SUNDRY NOTICES AND REPORTS ON WELLS
Do not use this form for proposals to drill or to re-enter an abandoned well. Use form 3160-3 (APD) for such proposals.

5. Lease Serial No. NMNM045276
6. If Indian, Allottee or Tribe Name
7. If Unit or CA/Agreement, Name and/or No.
8. Well Name and No. PRESTON FEDERAL 1
9. API Well No. 30-015-20349
10. Field and Pool, or Exploratory DAGGER DRAW, UPPER PENN, S
11. County or Parish, and State EDDY COUNTY, NM

Yates Petroleum Corporation plans to plug and abandon this well as follows:

Wellbore schematics attached

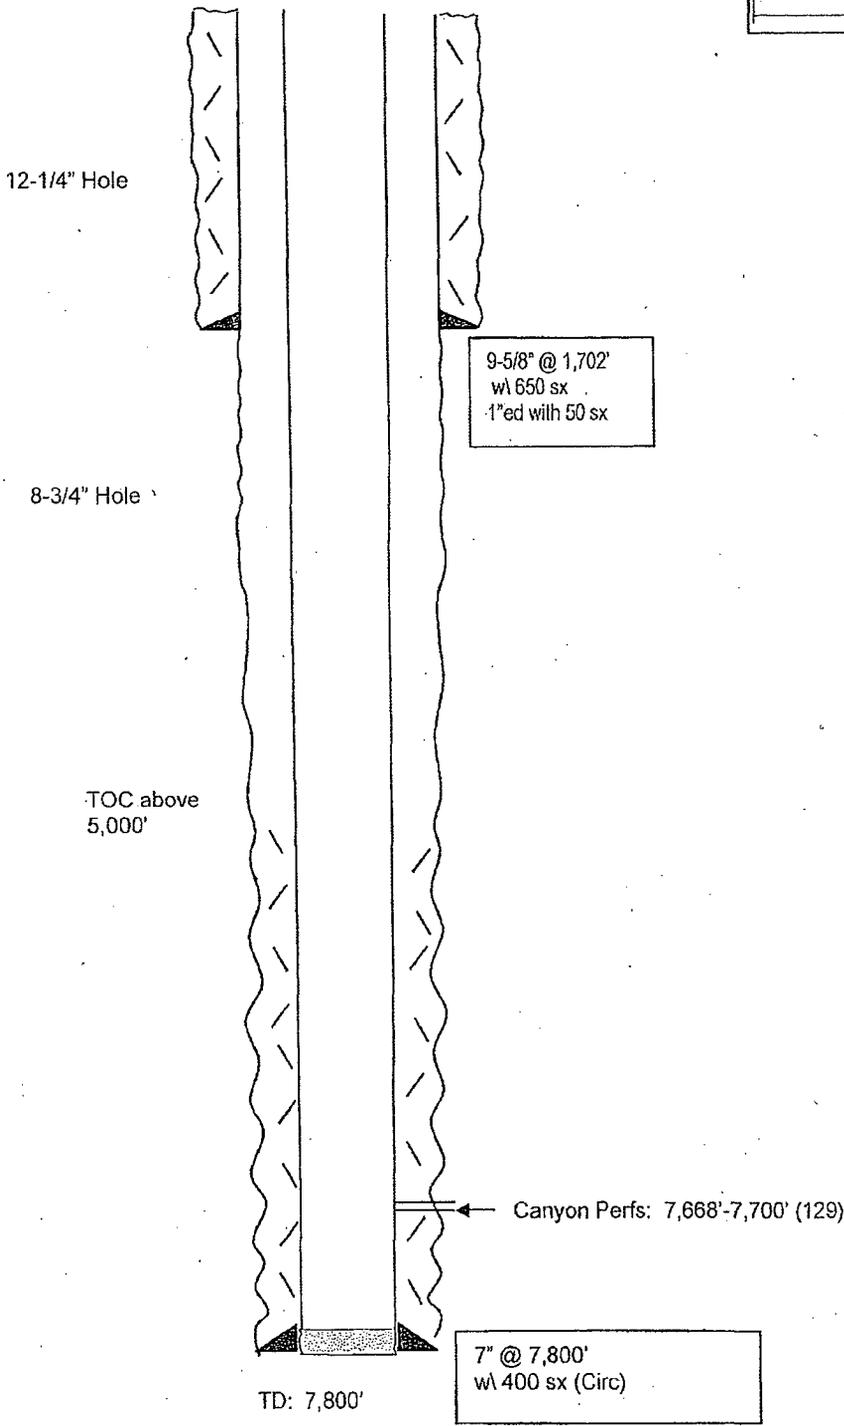
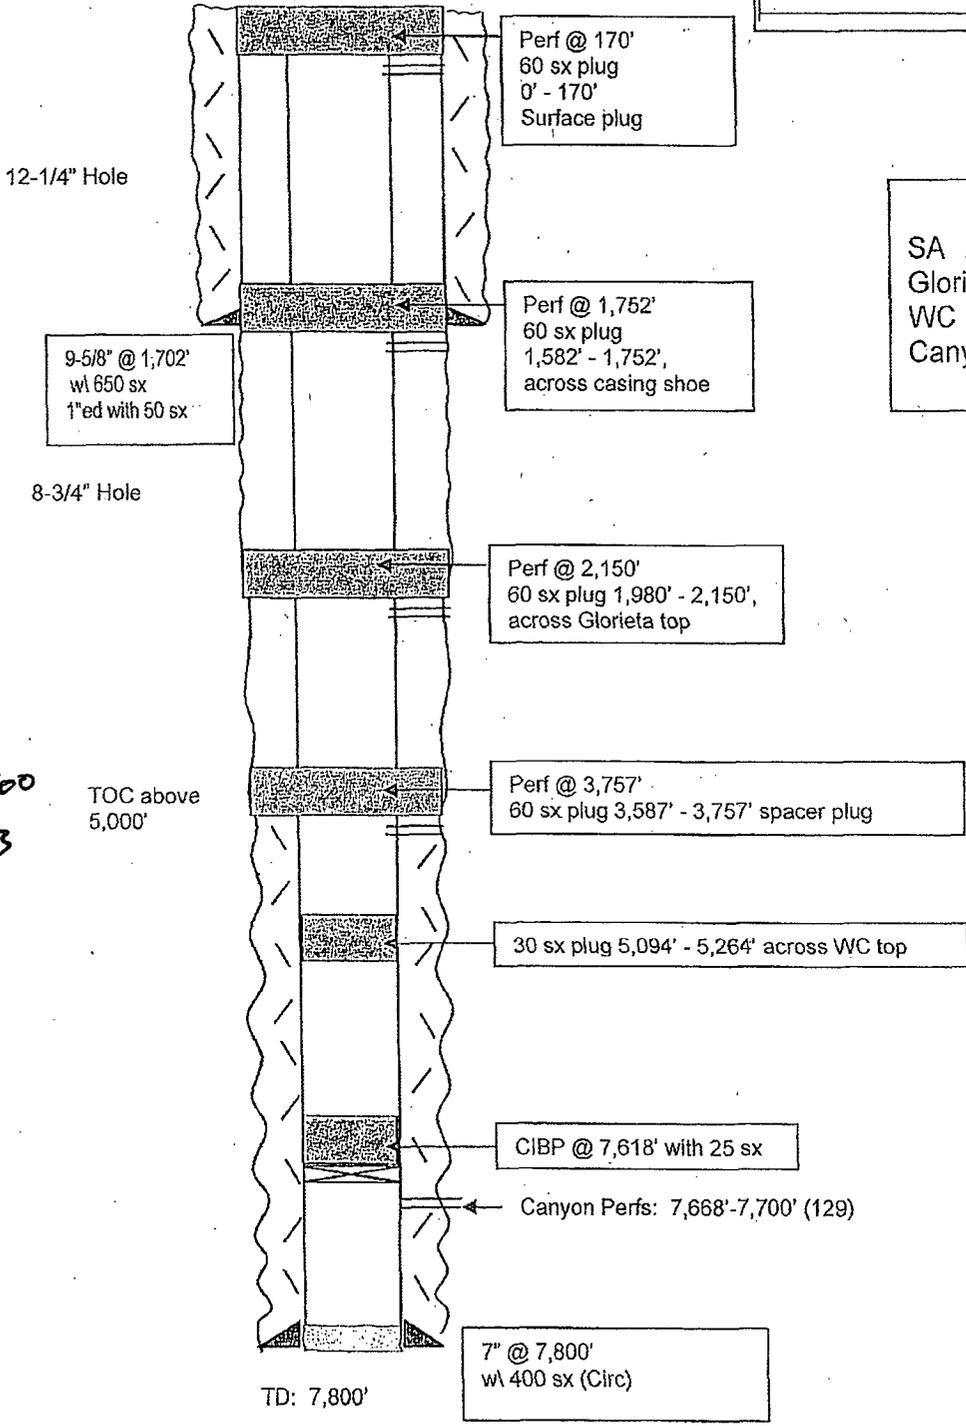
*Cmt to 7290' cover top of Canyon.
Perf & SQZ cmt from 5264
5094. WOC Tag*
